**Department of Veterans Affairs**  
**Barrancas National Cemetery Phase Two Design-Build**  
**Solicitation Number: VA101-16-R-0142**  
**Phase Two: Request for Proposal (RFP)**  
**Requested Information/Clarification**

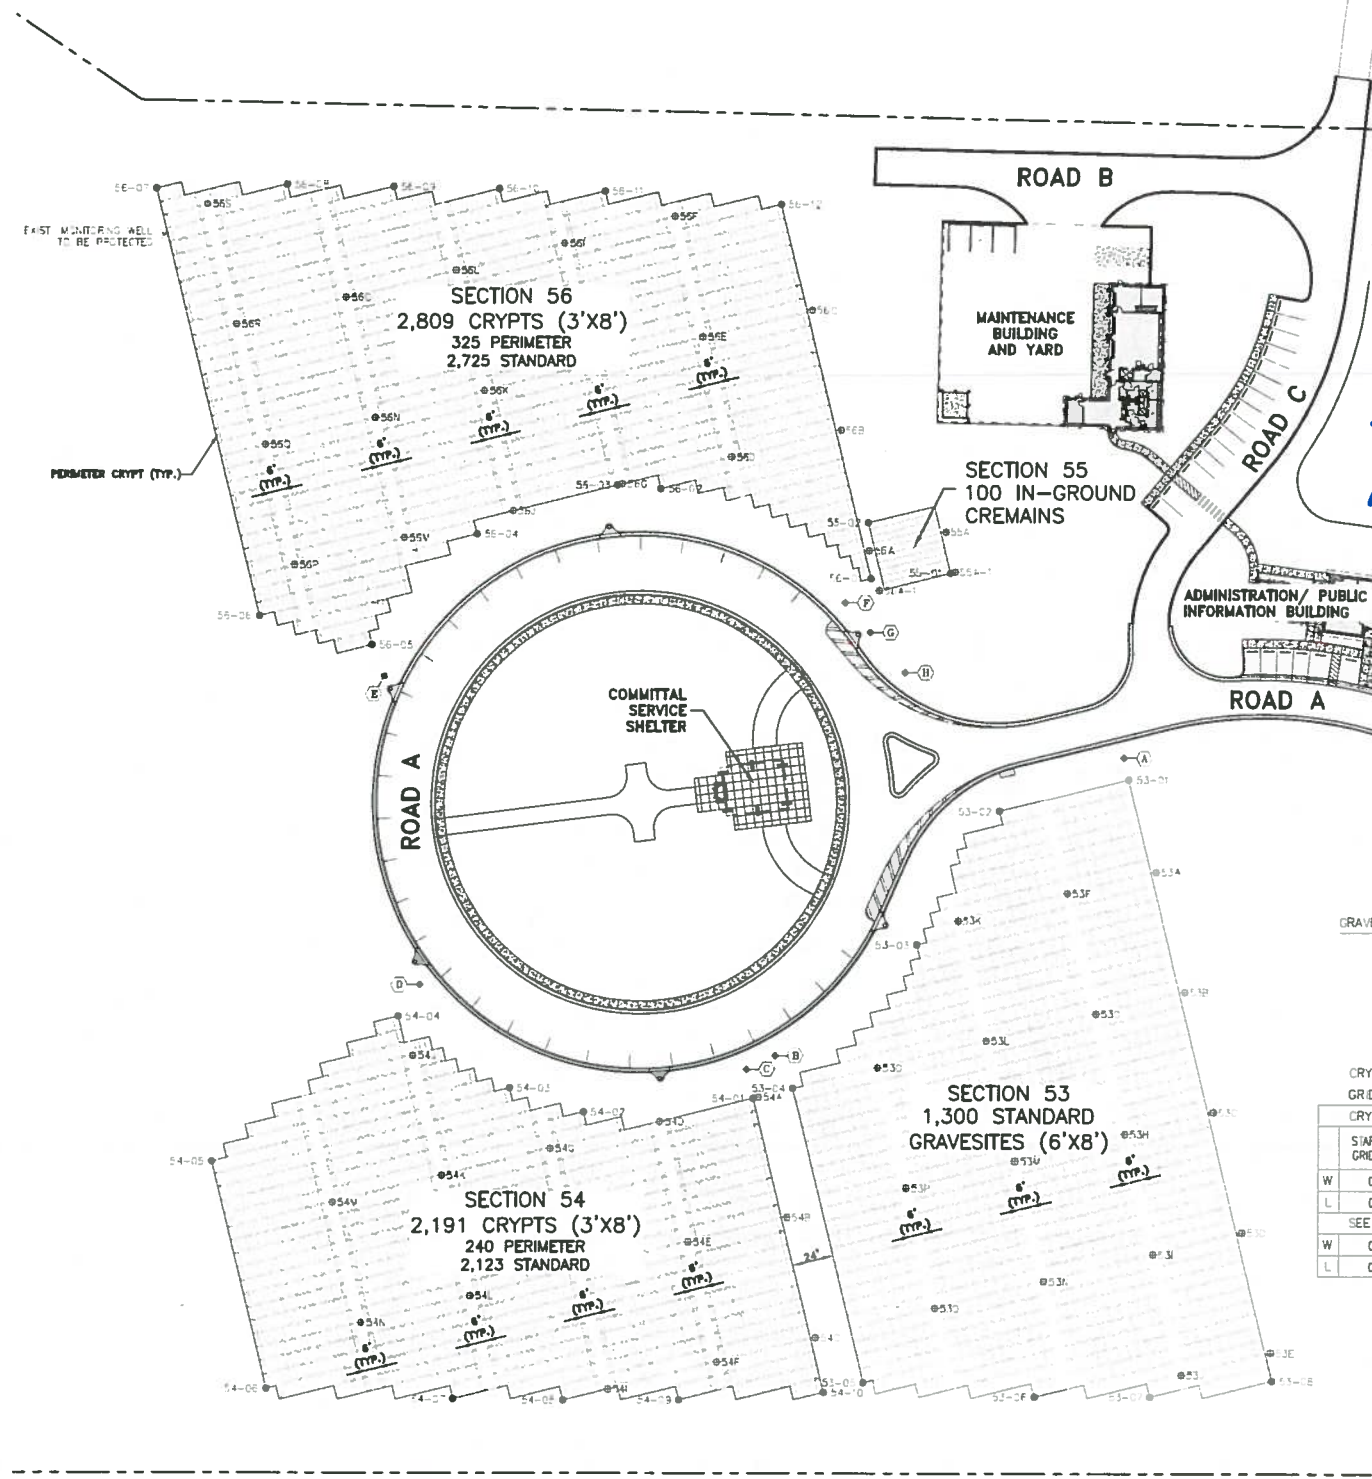
1. Please verify if these are the interment site sizes to use:

A single traditional gravesite is in a 6'x8' grid (two full casket spaces side by side that are each 3'x8') x 8')

A single pre-placed crypt is in a 3'x8' grid

A single oversized pre-placed crypt is in a 4'x10' grid

*the 6'x8' plot is considered one gravesite and we need 350 traditional gravesites that are 6'x8'*

*please verify if these are to remain the same for the D/B project*

**VA CFM Response: Interment sizes referenced in AE email are confirmed - see diagram below.**
